**TOWN OF ERIE
PLANNING COMMISSION MEETING
August 7, 2019**

SUBJECT: **Agenda # 19-322**

Review of Colliers Hill Filing No. 4G Sketch Plan

PURPOSE: Review and comment on a Sketch Plan application for 201 single-family detached units.

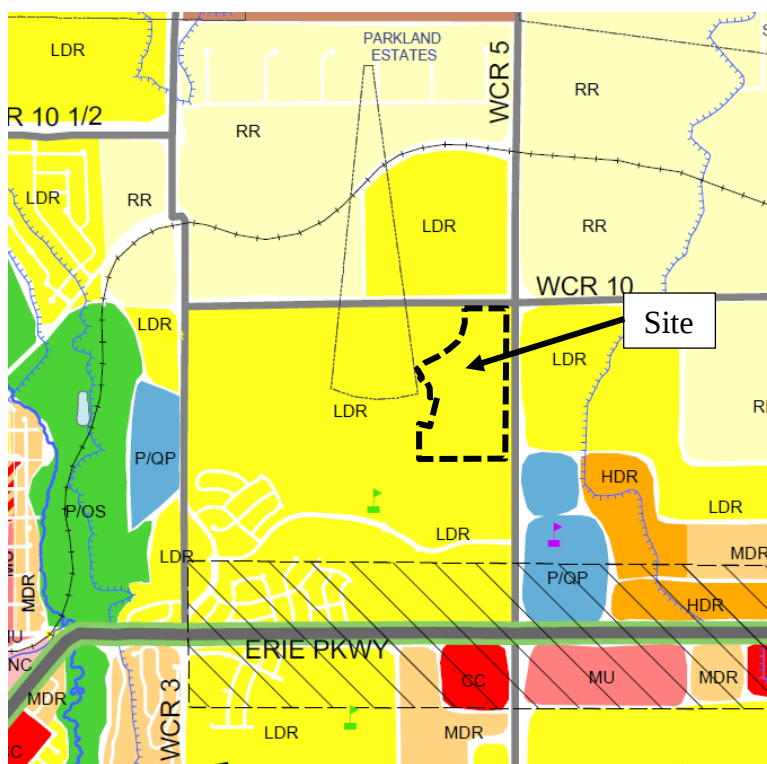
A Pocket park is required per the UDC and PUD and is depicted on the Sketch Plan. Pocket parks shall comply with all Town Standards and Specifications. All parks and amenity areas will be accessible to the residents via trail linkages and block crossings. Pedestrian areas will tie into the larger open space and trails network with the overall Colliers Hill Development.

The Parks Department stated concerns with the lack of on street parking contiguous to the neighborhood park. Parks also requested the lots on the east of the park to be removed. Further discussions will be required prior to Preliminary Plat.

Future plan submittals should illustrate how parks and trails connections are being made to the existing and proposed trail and park infrastructure. The Parks Division has provided the applicant with comments.

Sketch Plan & Bridgewater P.U.D. Amendment 4 Overlay

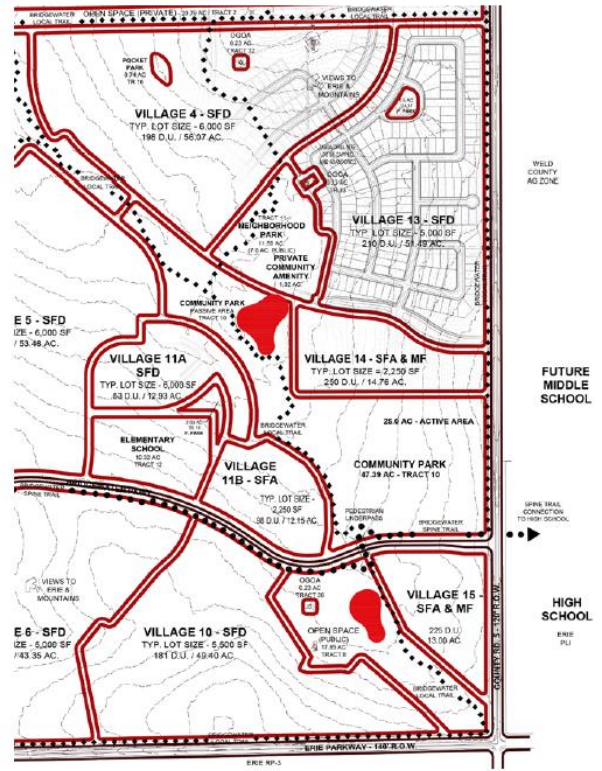
The proposed Sketch Plan is inconsistent with the existing PUD. Because of the applicant's proposed Sketch Plan, an amendment to the PUD to allow the project is required.

- Expanding standard Single-Family Detached lots of 5,000 square feet or more by 51.5 acres, which would allow up to 210 dwelling units. This expansion would combine Villages 13 and 14.
- Eliminating Village 13 consisting of 210 patio homes (3,500 to 5,000 square foot lots) on 41.29 acres.
- Eliminating Village 14 consisting of 33 acres with 260 units of townhomes and duplexes.
- Change Village 15 from 9.5 acres with 250 dwelling units of apartment only dwellings to 14.76 with 250 units of single-family attached (townhomes or multi-family apartments).
- Change Village 16 from 13 acres with 225 apartment only dwelling units to 13 acres with 225 single-family attached and/or multi-family.

The proposed amendment significantly reduces the land area dedicated to alternative housing types.
